**MINUTES**  
**VILLAGE OF CHESTER PLANNING BOARD**  
**OCTOBER 26, 2021**  
**REGULAR MEETING**

**PROJECT NAME:** ADVANCE AUTO SITE PLAN  
**PROJECT LOCATION:** 93, 95 & 97 BROOKSIDE AVENUE  
SECTION 107 – BLOCK 02 – LOTS 08.21, 09.01 & 09.02  
**PROJECT NUMBER:** 21-02  
**DATE:** 26 OCTOBER 2021  
**CONSULTANT:** KEPLINGER, FREEMAN ASSOCIATES, LANDSCAPE ARCHITECTURE  
AND LAND PLANNING  
**PLAN DATE:** 12 OCTOBER 2021  
**DESCRIPTION:** THE APPLICATION PROPOSES THE CONSTRUCTION OF A 6,689 SQUARE  
FOOT ADVANCE AUTO PARTS STORE WITH ASSOCIATED PARKING AND  
STORMWATER FACILITIES AND LOT LINE CHANGE. THE APPLICATION WAS  
PREVIOUSLY REVIEWED BY THE BOARD AT THE 27 APRIL 2021, 1 JUNE 2021,  
22 JUNE 2021, 27 JULY 2021 AND 28 SEPTEMBER 2021 PLANNING BOARD  
MEETINGS.

## 1 LAYOUT and PLANTING PLAN

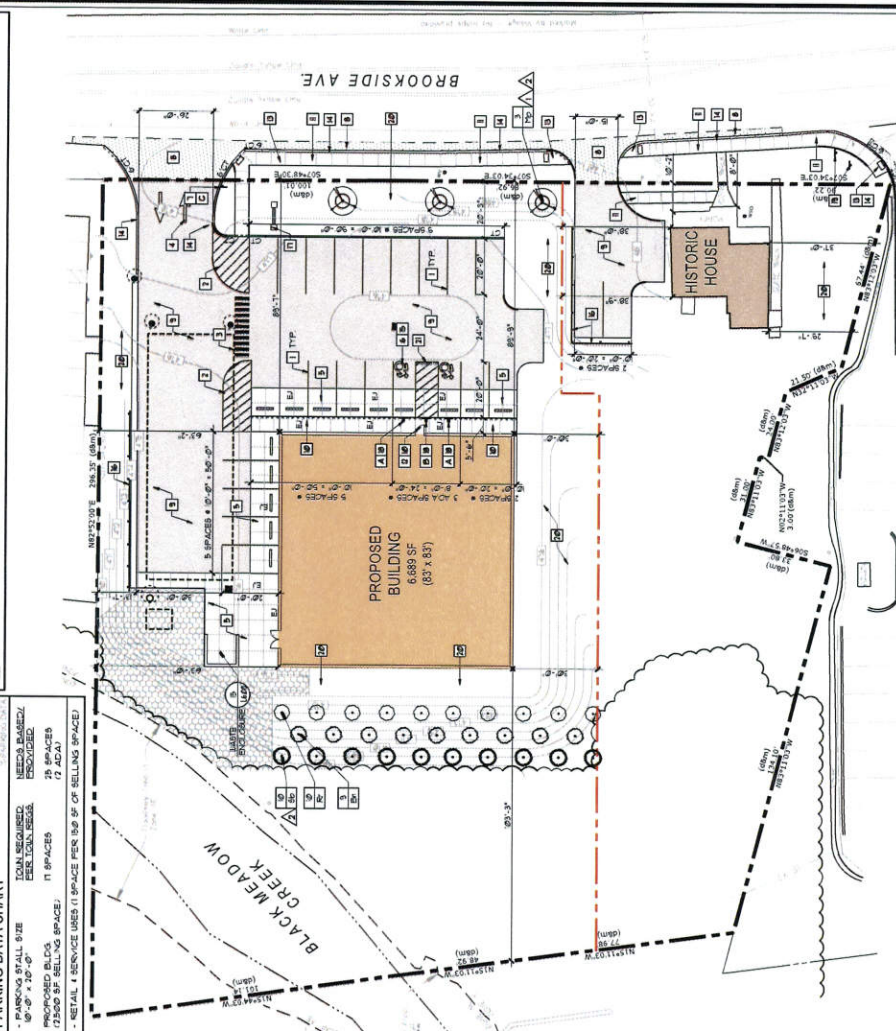
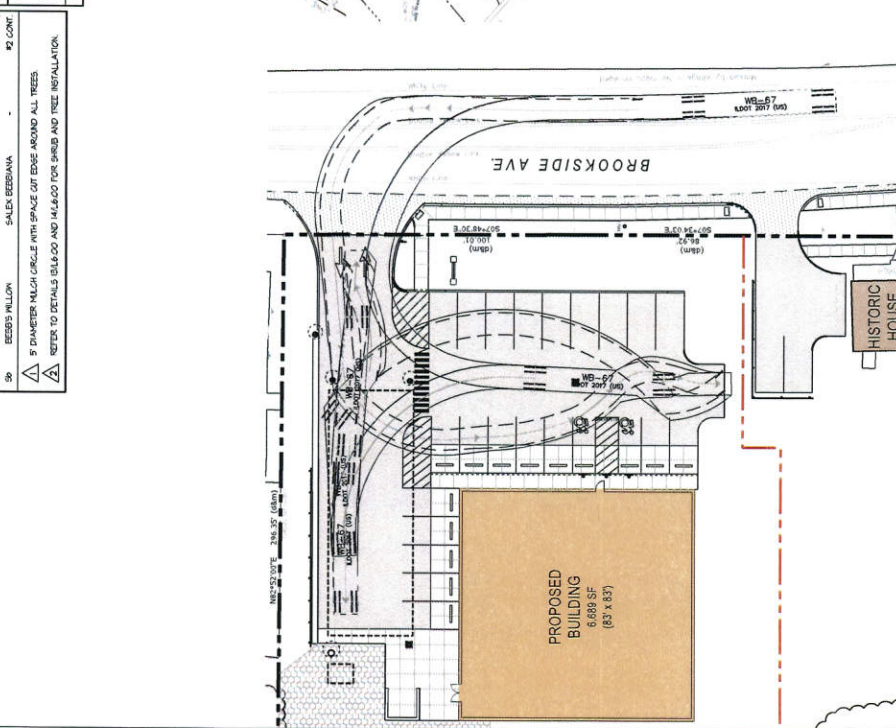
- Upon examining "LAYOUT and PLANTING PLAN L2.00" I see no indication that it responds to my first question about where will the fifteen unloading employees park. The "truck navigation" shows only seven parking spaces fully clear (marked in magenta) of the truck's path, one of those being a "Handicap" spot. The depicted path indicates three other parking spaces are barely encroach upon (purple). It looks to me like only spots numbered 1 - 5 are reasonably safe, 6 - 10 being too close to the truck's path to risk, especially in inclement winter conditions when the truck may not track precisely as the driver expects.

- First question: Mark Shattuck, the applicant, stated that approximately 15 employees would be on the site to unload the truck. Where would these employees park their cars (up to fifteen), and how would the depicted 80'± truck maneuver in this smaller parking lot and avoid those employee cars?

**1 MONUMENT SIGN**

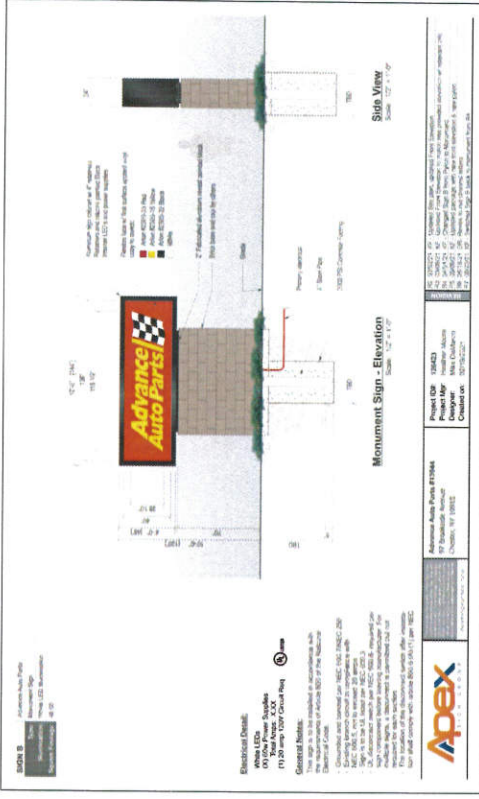
The Monument Sign - Elevation (L6.10) shows the total height of the sign above grade at 10 feet. This is not in compliance.

**§98-19, C (4) & E:**

"A ground-mounted sign shall not project more than five feet above the ground."
